# UNITED STATES PATENT AND TRADEMARK OFFICE

APPLICATION NO.	FILING DATE	FIRST NAMED INVENTOR	ATTORNEY DOCKET NO.	CONFIRMATION NO.
09 836,351	04/18/2001	Jang-Jin Yoo	8733.421.00	8728

## Office Action Summary

## DETAILED ACTION

**FIG. 11**

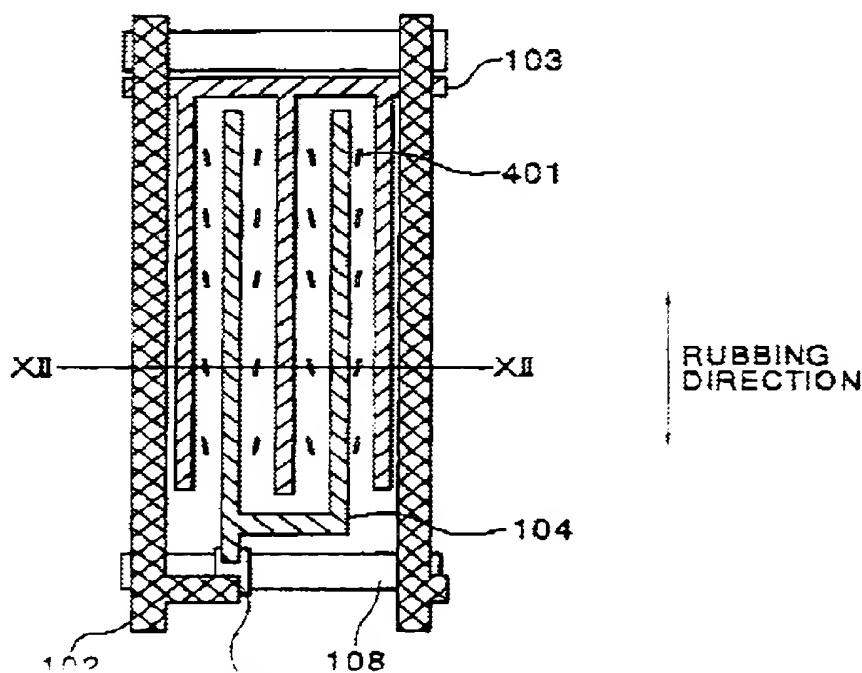
As to claim 1, Watanabe discloses in the first embodiment (col. 5, line 51 through col. 8, line 5 and Figures 11, 12, and 16), an IPS-LCD device, comprising: first, 101, and second, 201, substrates opposing each other; a scanning (Applicant's gate) line, 108, on the first substrate; a signal (Applicant's data) line, 102, perpendicular to the gate line; a thin film transistor, 109, at a crossing portion between the gate and data lines; a common electrode (portion running left to right in Figure 11 Applicant's common line)

bottom in Figure 11), 103, electrically connected to the common line, wherein the common electrodes are spaced apart from each other; a plurality of pixel electrodes, 104, alternately arranged with the plurality of common electrodes, wherein each pixel electrode is spaced apart from an adjacent common electrode; a plurality of insulator films (Applicant's dielectric protrusions), 105 and 106, between the first and second substrates; and a liquid crystal layer, 301, between the first and second substrates, wherein the liquid crystal layer and the dielectric protrusion have different dielectric constants as evidenced by Figure 16 and Table 2 (col. 7, lines 31-42).

FIG. 16

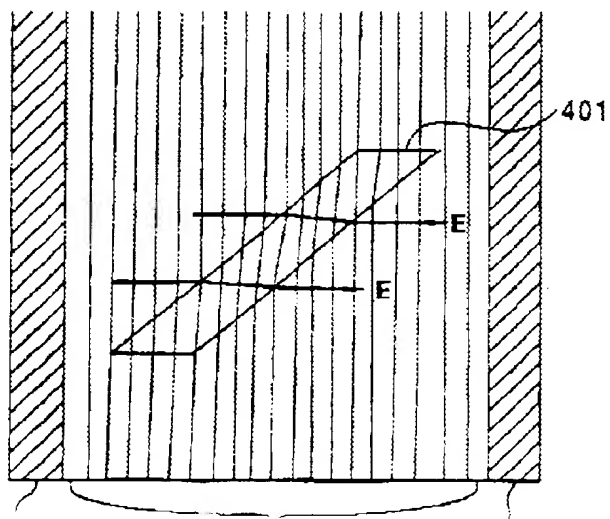
As to claim 2, Watanabe discloses the dielectric protrusion has a smaller dielectric constant than the liquid crystal layer in Table 2 (smaller than major axis, col. 7, lines 31-42).

FIG. 2B

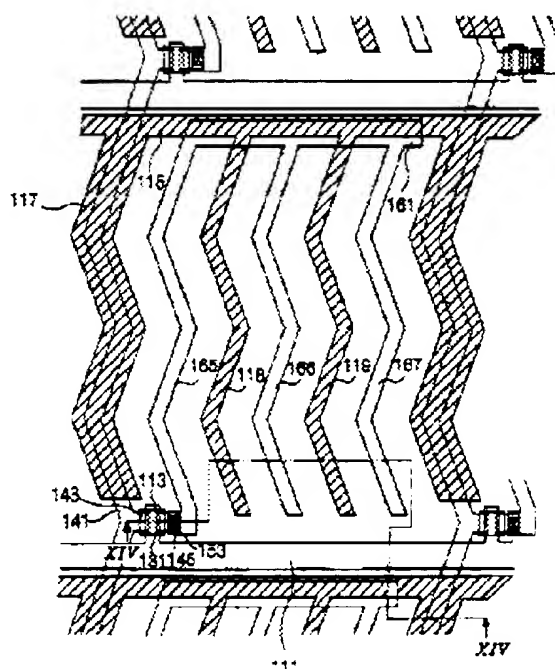
Lee teaches in Figure 2 an IPS LCD with negative or positive dielectric anisotropy (col. 2, lines 25-26), and Lee teaches the rubbing direction is changed to be compatible with the anisotropic characteristics of the liquid crystal material (col. 3, lines 47-65) to achieve proper switching of the liquid crystal material. Note that some of the angles are improperly expressed, however, one of ordinary skill in the art of liquid crystals would understand that the LC molecules of negative dielectric anisotropy are aligned substantially perpendicular to the electrodes in the off state.
